1. Type of Well S Oil Well Gas Well Other				8. Well Name and No. FARRELL FEDERAL 8	
	2. Name of Operator Contact: LAURI M STANFIELD RIDGEWAY ARIZONA OIL CORP E-Mail: Istanfield@hunteroil.com				9. API Well No. 30-041-10440	
	3a. Address 3b. Phone No. (include area code) 777 NORTH ELDRIDGE PARKWAY, SUITE 150 Ph: POBBS OCD HOUSTON, TX 77079 Phone No. (include area code)				10. Field and Pool or Exploratory Area CHAVEROO - SAN ANDRES

Plugging Procedure Farrell Federal #8 API - 30-041-10440 Sec. 28, T7S, R33E, UL-E 1980' FNL 660' FWL

Farrell Federal 8 30-041-10440 Ridgeway Arizona Oil Corp July 2, 2018 Conditions of Approval

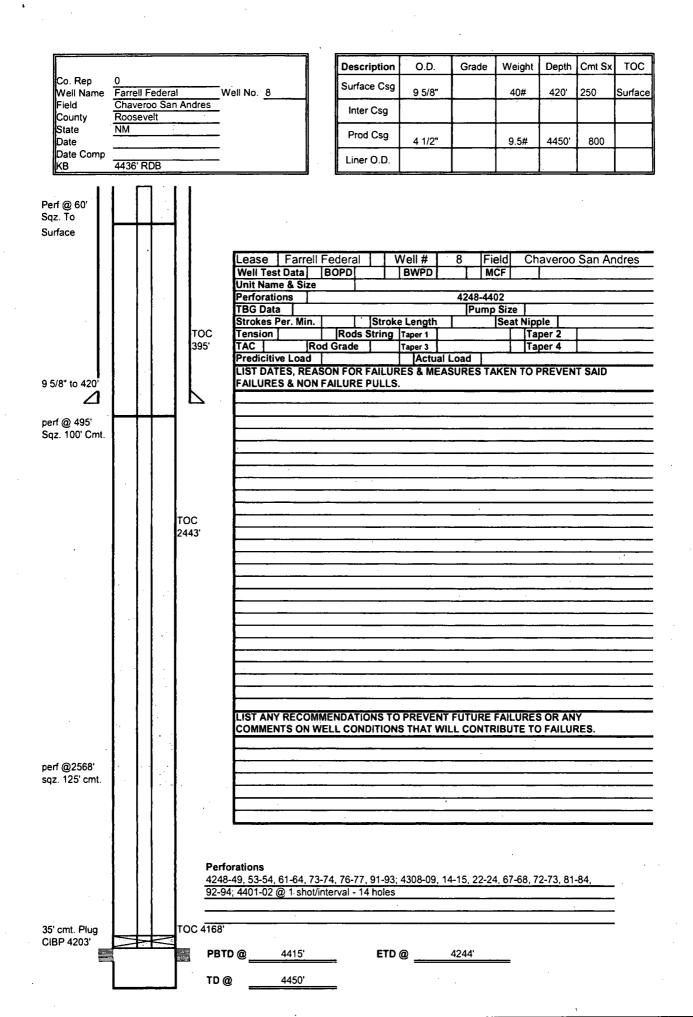
- 1. Operator shall place CIBP at 4,198' (50'-100' above top most perf) and place 35' of Class C cement on top as proposed. <u>WOC and TAG.</u>
- 2. Operator shall perf and squeeze as proposed at 2,568'. Operator shall place a balanced Class C cement plug from 2,568'-2,240' to seal the top of the Yates formation. <u>WOC and TAG.</u>
- 3. Operator shall perf and squeeze at 2,100'. Operator shall place a balanced Class C cement plug from 2,100'-1,950' to seal the top of the Salt formation. <u>WOC and TAG.</u>
- 4. Operator shall perf and squeeze at 470'. Operator shall place a balanced Class C cement plug from 470'-370'' to seal the top of the Shoe. <u>WOC and TAG</u>.
- 5. Operator shall perf and squeeze at 60' bringing cement to surface.
- 6. See Attached for general plugging stipulations.
